2 Type of change

- Nickel plated case instead of aluminium case
- Production transfer from Slovakia (SK) to Romania (RO)

Product Change Notification					PCN FMW-52 and FMAB case 09 redesign		
owner	creation date	release date	released by	change order no	rev	page	D10-032-874
segatro	04.01.2019	16.01.2019	romanogu	2016836	A	1 of 2

Old mechanical drawing	New mechanical drawing
<p>Case 09 with quick connect terminals class I</p>	<p>Case 09 with quick connect terminals class I</p>
<p>Case 09 with quick connect terminals class II</p>	<p>Case 09 with quick connect terminals class II</p>

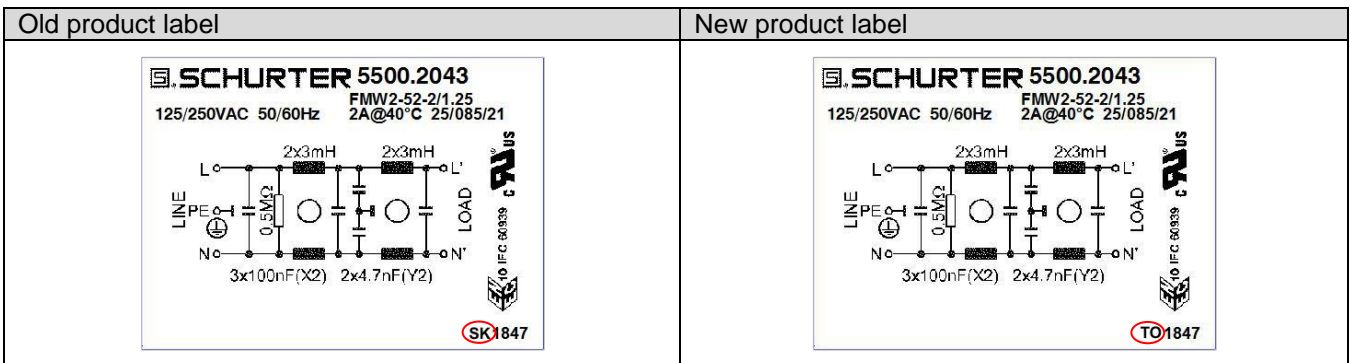
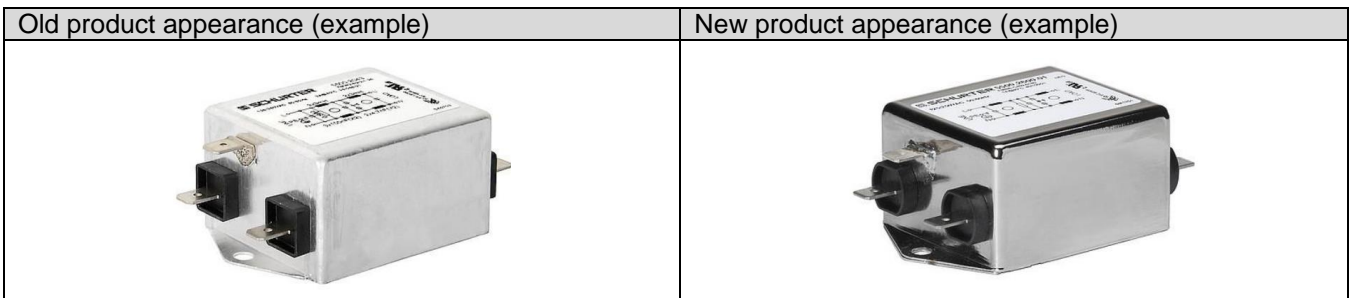
- Change of product appearance due to new nickel plated case instead of aluminium case and different shape of plastic part for quick connect terminals see photo below
- Change of factory code from SK to TO and origin from SK to RO on product and packaging labels, see below
- Different shape of plastic part for external quick connector terminals
- New cases are provided with a bottom cover
- Position of earth terminal

Form	Yes	New material and different quick connect terminals
Fit	Yes	Earth terminal position
Function	No	No change in function
Manufacturing	Yes	Change of production site
Label	Yes	Change on label
Packaging	No	Change in packaging
